Service Information 7SA511 Firmware Update to V3.24A (EPROM Exchange)

Firmware versions **V3.24AD** (German) and **V3.24AE** (English) for the distance protection relay **7SA511** are now available.

Fig. 1: KSP1-p-c board, back with fixing screws

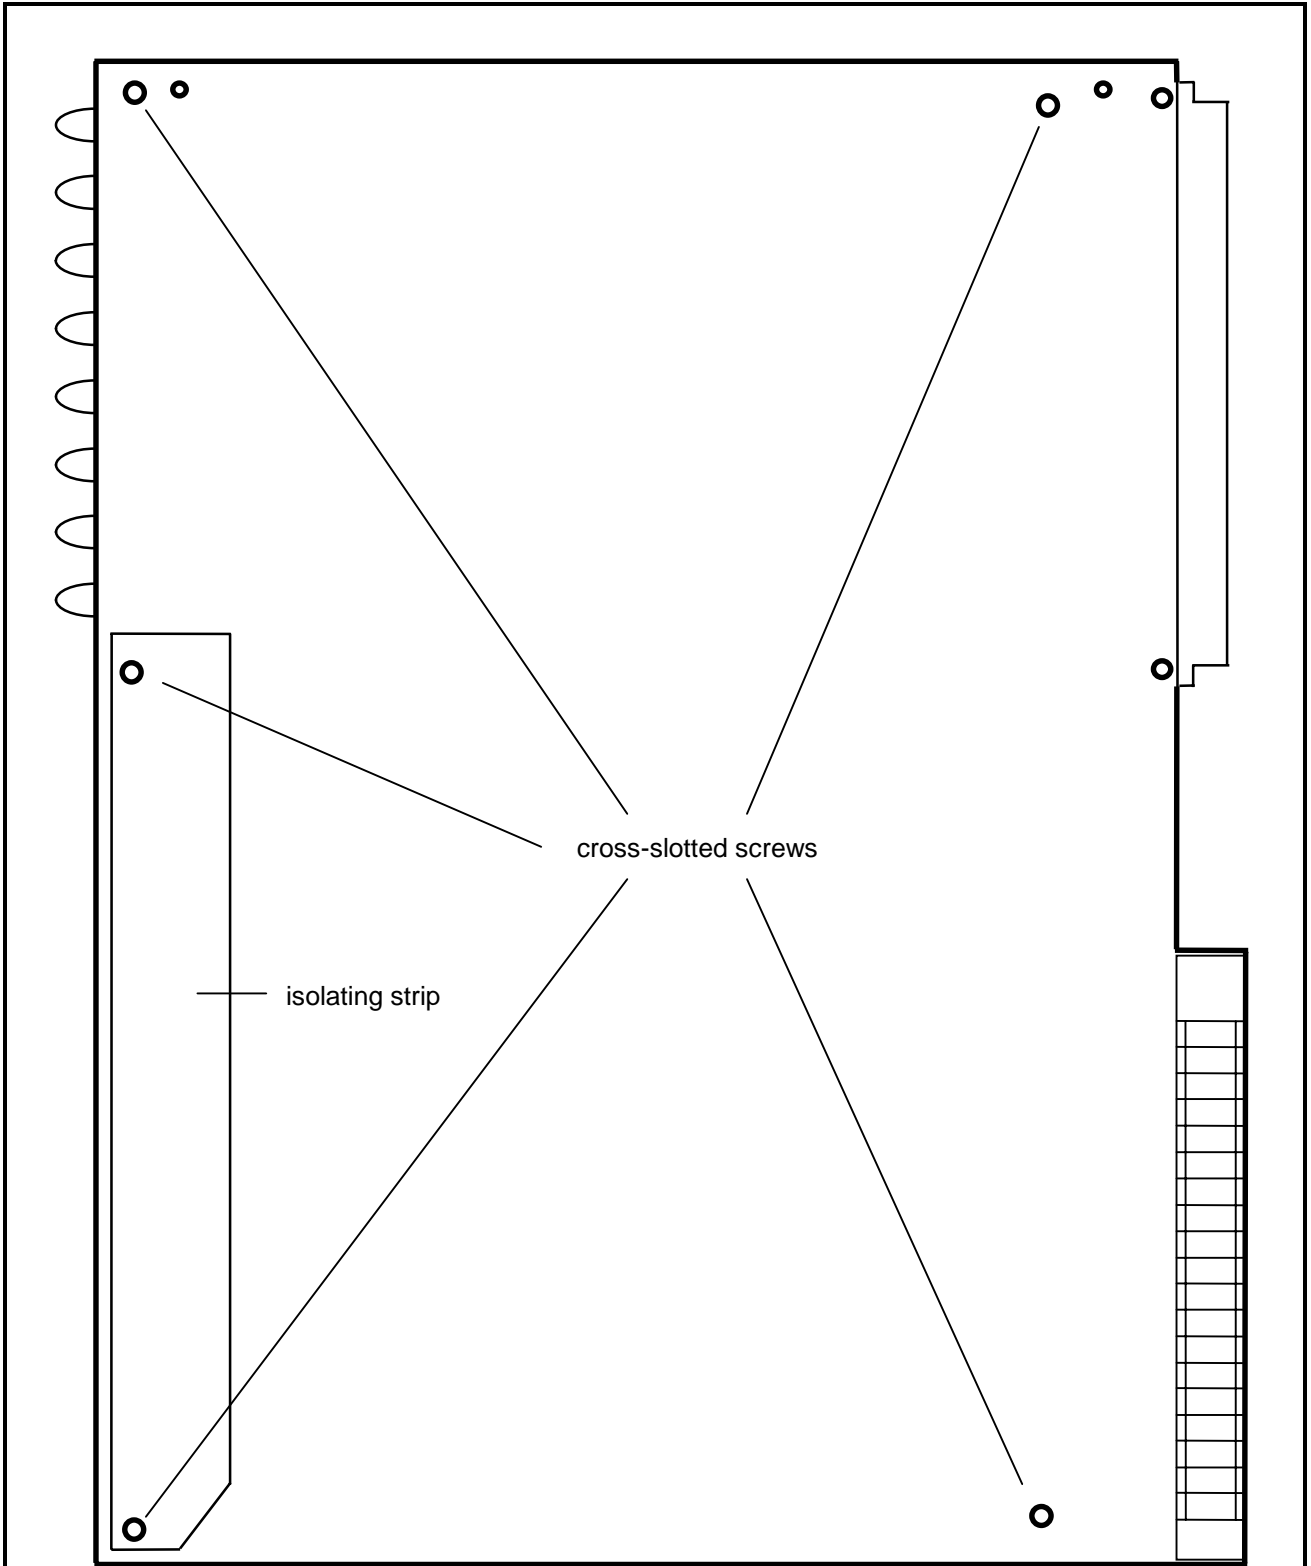
9. Remove the five cross-slotted screws and the isolating strip from the back of the p.-c. board (see fig. 1 on page 6).
10. Lift up the p-c board slightly and remove all plugs of the cable joints from the p.-c. board.

14. Replace all plug-in connectors carefully and make sure, that no pins suffer injury (bending) during insertion.
15. Fix the p.-c. board with the five screws and the isolating strip on the compact unit (see fig. 1 on page 6)

Fig. 2: KSP1 - p-c. board, component side and position of EPROM D35

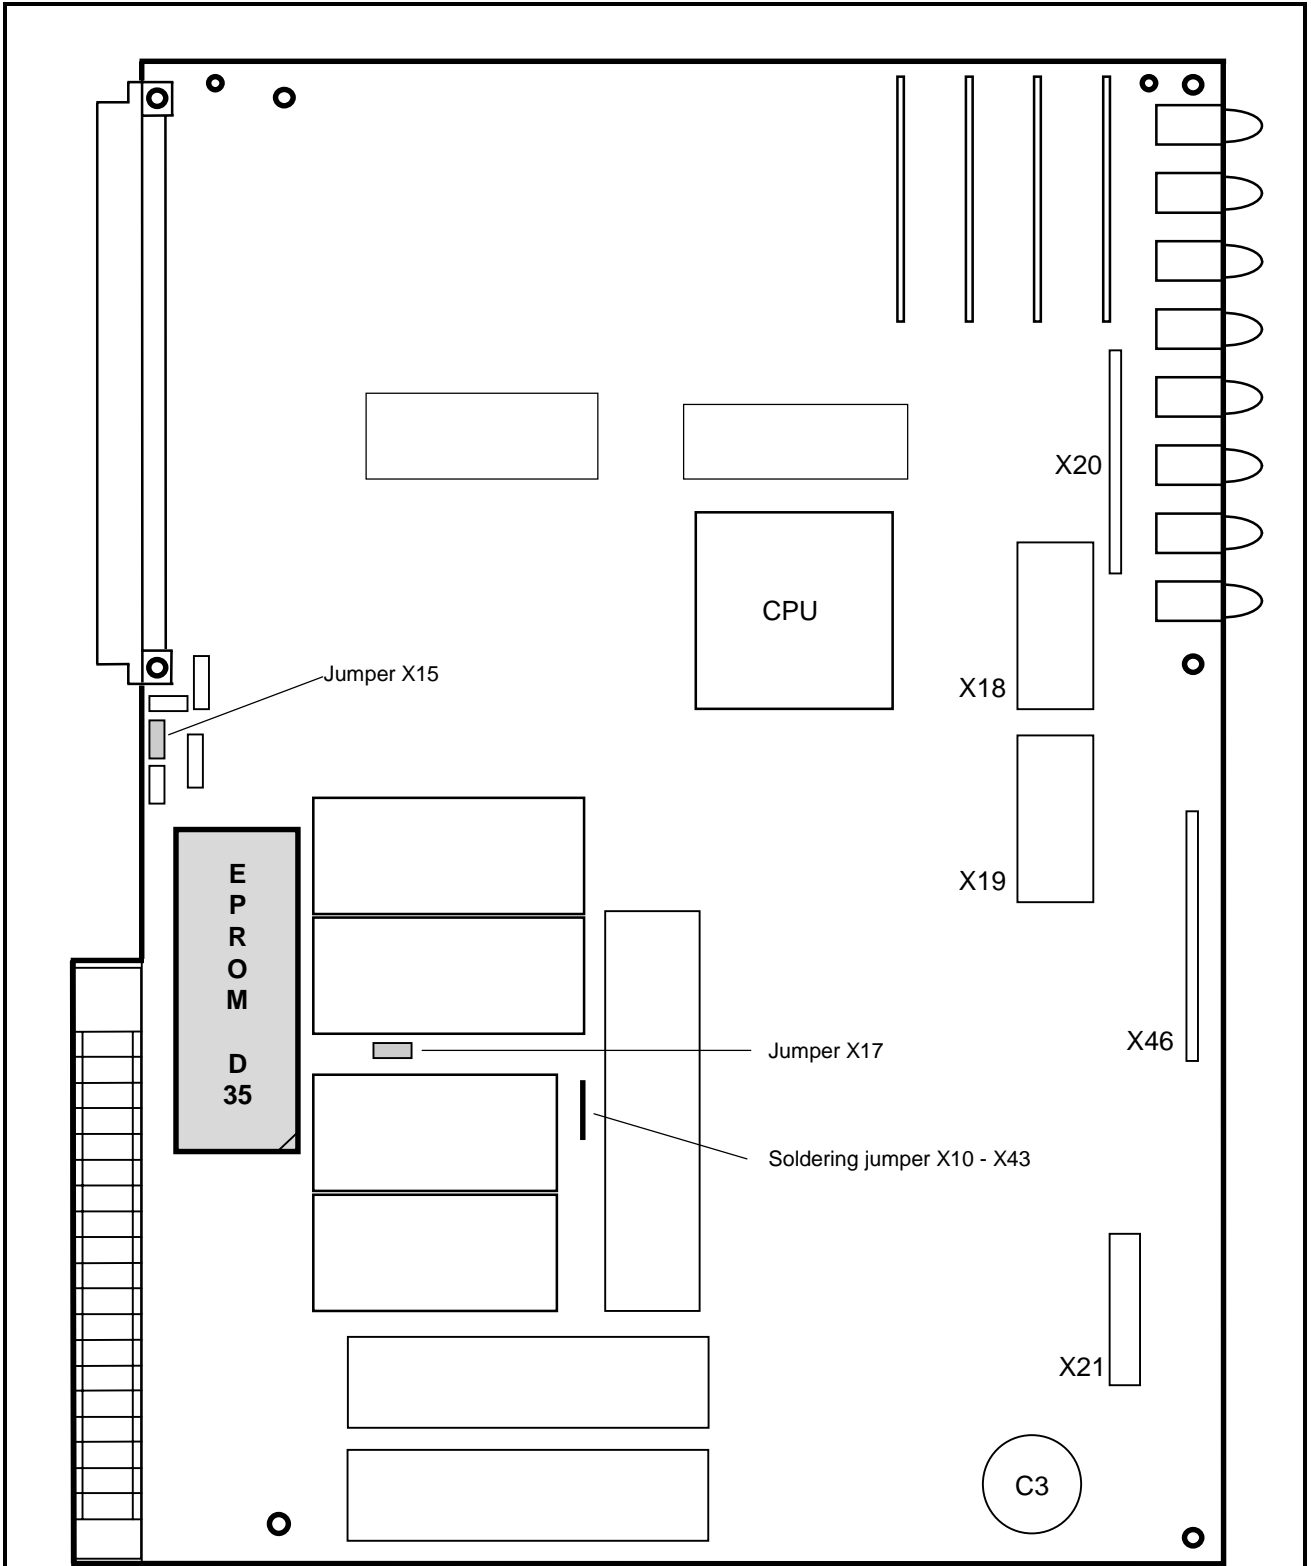
11. Carefully remove the EPROM with the previous firmware version (IC location D35, see fig. 2 on page 7) by levering it out of its IC base.

12. Carefully insert the new EPROM **P73509-B1-A168-5** (German) or **P73509-B1-A169-5** (English) into base D35 on the KSP processor board (see fig. 2 on page 7).
Make sure that the IC identifier corresponds to the base identifier and that no terminal pins of the EPROM suffer injury (bending) during insertion.
